## Agenda Item # 7 SUB-002990-2024

Woodcock Place Subdivision

- Subdivision approval to create twenty-two (22) legal lots of record from one (1) metes-and-bounds parcel.

APPLICATION NUMBER 7 DATE July 18, 2024

# WOODCOCK PLACE SUBDIVISION

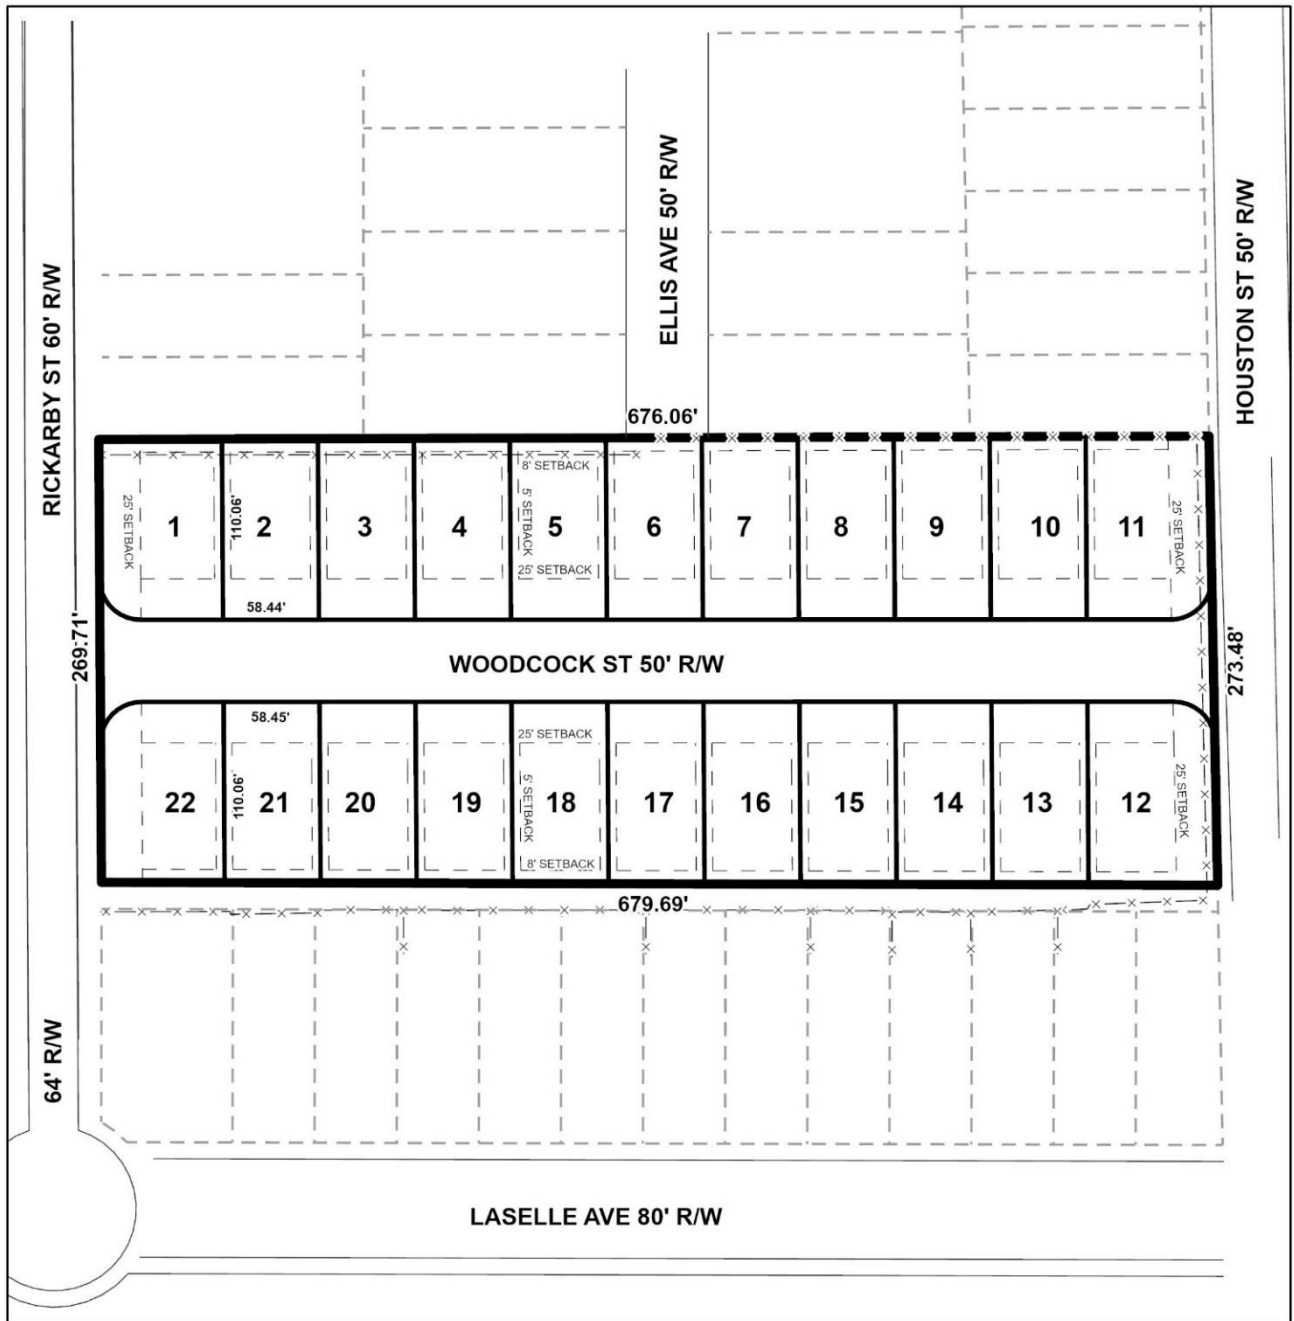
- A. Provide all of the required information on the SUBDIVISION PLAT (i.e. signature blocks, signatures, certification statements, written legal description, required notes, legend, scale, bearings and distances) that is required by the current Alabama State Board of Licensure for Professional Engineers and Land Surveyors.

- B. Add a graphic scale.
- C. Add a vicinity map including legible street names.
- D. Label the proposed ROW as either "PUBLIC" or "PRIVATE".
- E. Provide a table of "PROPOSED WEIGHTED RUNOFF COEFFICIENT (Cw)" for each LOT.

- F. Add a signature block for the City of Mobile Planning Commission and Traffic Engineer.
- G. Revise the County Engineer signature block to "CITY ENGINEER". This subdivision is located within the City of Mobile.

- H. Revise the approval statement from "Mobile County Commission" to "PLANNING COMMISSION". This subdivision is located within the City of Mobile.
- I. Revise the FLOOD CERTIFICATE to indicate that the property is located within the "X(U)" flood zone.

- J. Delete the eleventh and twelfth SURVEYOR'S NOTES. Both notes include reference to the MOBILE COUNTY requirements. This subdivision is located within the City of Mobile.

- K. Add a note that the proposed roadway and stormwater improvements shall be complete and approved prior to issuing any residential construction permits.

- L. Add a note that the proposed Street ROW must be submitted for acceptance by the Mobile City Council prior to submitting the Final Plat for City Engineer signature.

As stated previously, the site is currently developed with Woodcock Elementary School. As such, if approved, the existing structure(s) should be removed from the site, with all necessary permits, prior to the signing of the Final Plat.

The preliminary plat depicts 25-foot front setbacks for all properties, along all street frontages. However, the Unified Development Code (UDC) allows a five-foot (5') front setback in R-1 Urban Districts. The plat also depicts side setbacks (5') and rear setbacks (8'), but these are not required to be shown on the plat, and should be removed, if approved. Furthermore, it should be noted that side and rear setbacks in an R-1 Urban District are both five-feet (5').

The preliminary plat depicts several easements, including: 25-foot drainage/utility easements along Houston Street and Rickarby Street, 10-foot utility easements along the front property lines, and 5-foot utility easements along the interior side property lines. If approved, all easements should be depicted and labeled on the Final Plat, along with a note stating that no structures are allowed to be built in an easement without the easement holder's permission.

The lots, as proposed, exceed the minimum size requirements for lots served by public water and sanitary sewer in an R-1 Urban district and are appropriately labeled in square feet and acres on the preliminary plat. Lot sizes

range from 6,436 square feet to 8,563 square feet. If approved, this information should be retained on the Final Plat; or placement of a table on the Final Plat with the same information will suffice.

1. Retention of the rights-of-way along all street frontages on the Final Plat;
2. Revision of the Final Plat to depict a minimum five-foot (5') front yard setback or retention of the proposed 25-foot (25') front setback;

3. Retention of the lot sizes in square feet and acres on the Final Plat or provision of a table on the Final Plat with the same information;
4. Removal of all side and rear yard setbacks from the Final Plat;

5. Depiction of all easements on the Final Plat;
6. Placement of a note of the Final Plat stating that no structures are allowed to encroach into an easement without the permission of the easement holder;

7. Removal of all existing structures on the subject site, with all necessary permits, prior to the signing of the Final Plat;
8. Compliance with all Engineering comments noted in this staff report;
